COMMERCIAL
BUILDING REVIEW

KIDD'S PLACE SHELTER

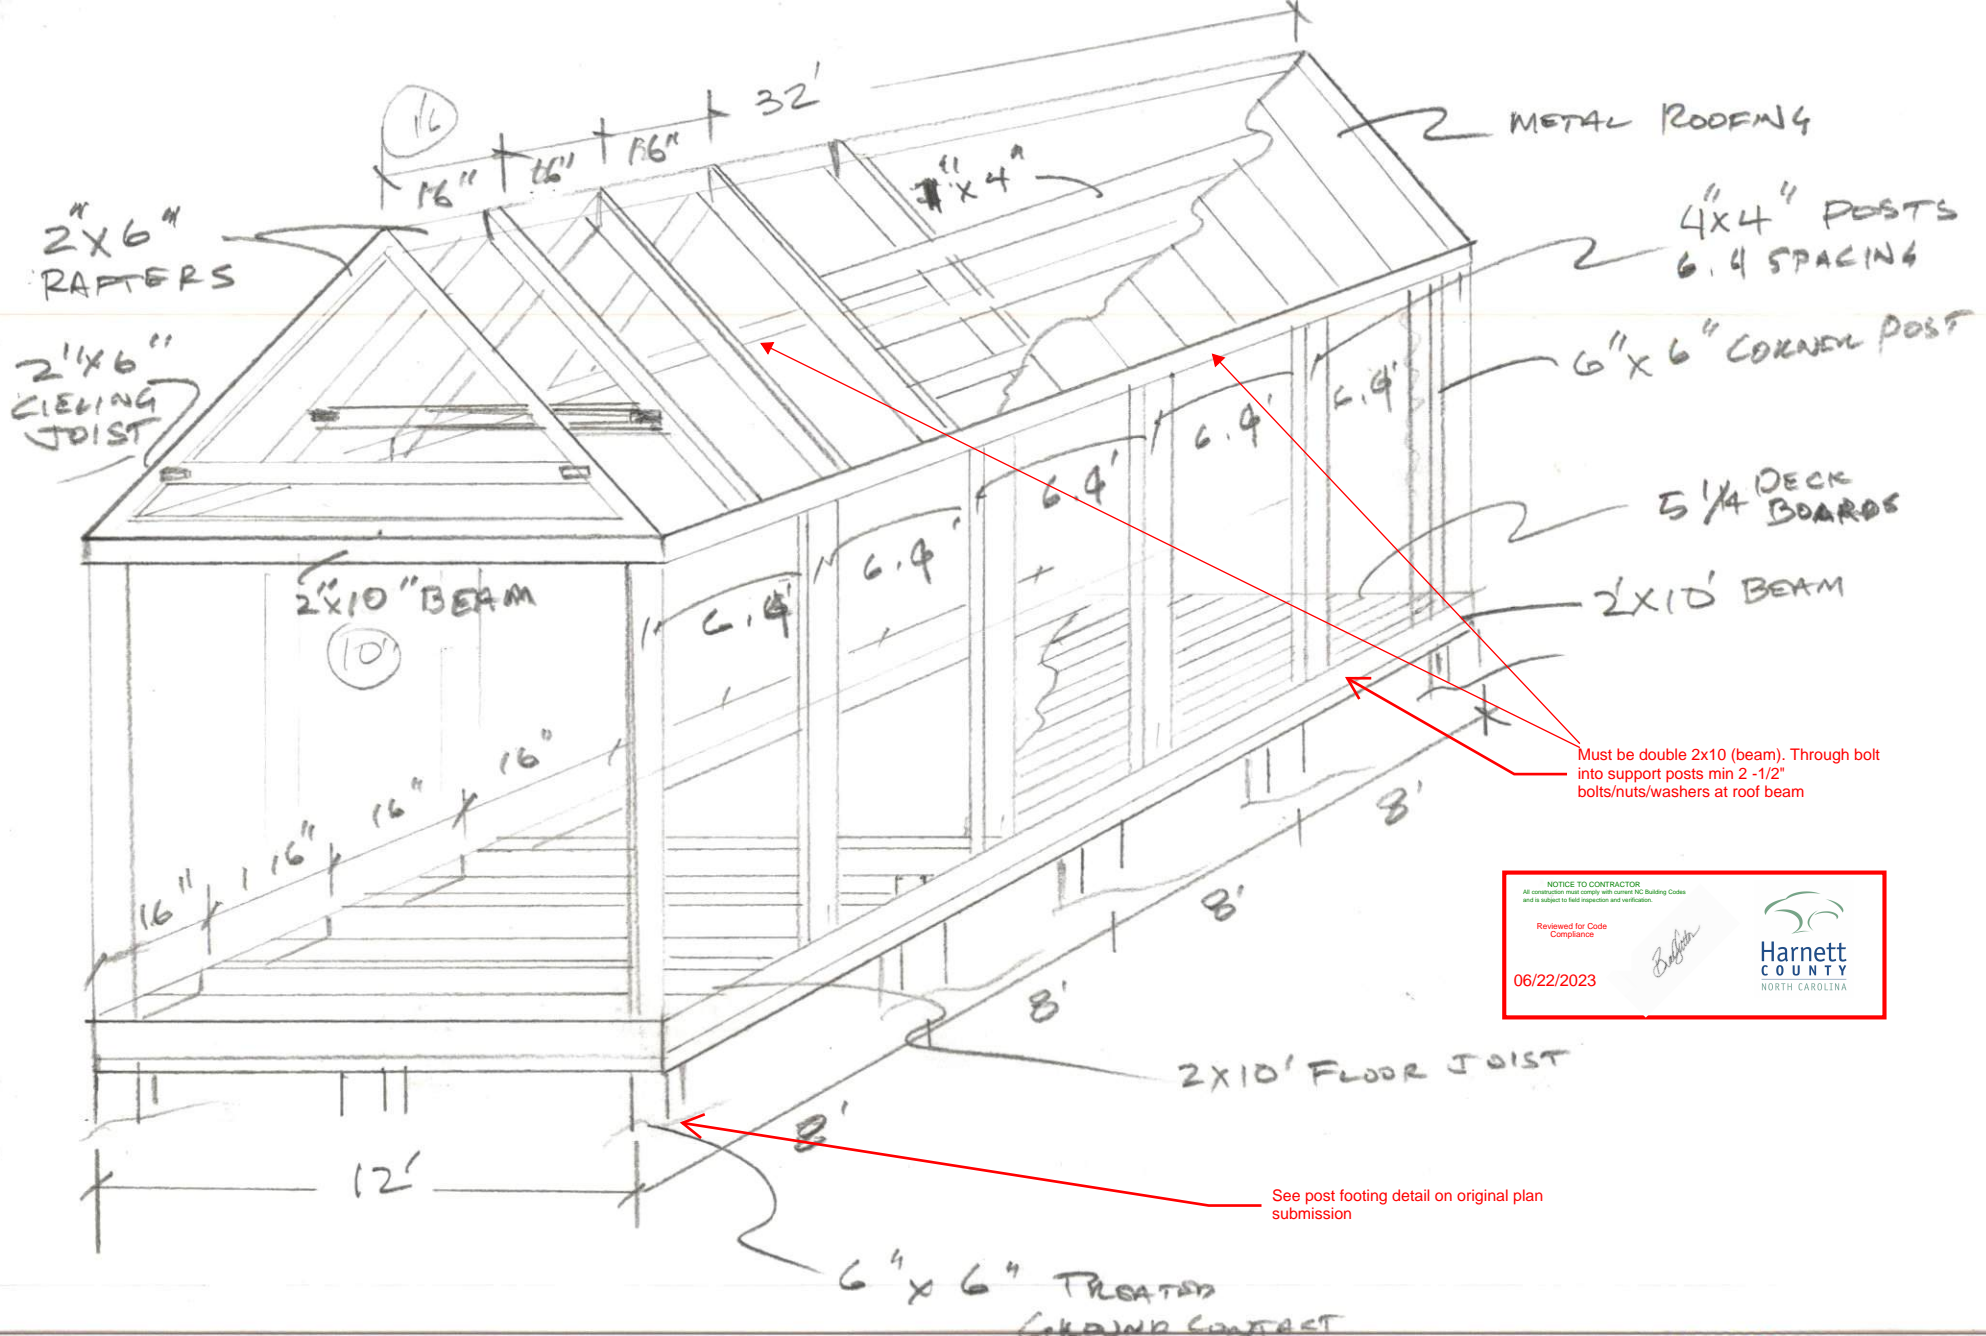
- ✓ 1. Need post spacing shown for deck and roof.
- ✓ 2. Need beam size shown for deck and roof.
- ✓ 3. Need floor joist size and spacing for deck and decking type
- ✓ 4. Roof must have ceiling joists in lower 1/3 of rafter span, or engineered trusses must be used. If using trusses, supply layout for truss supplier.
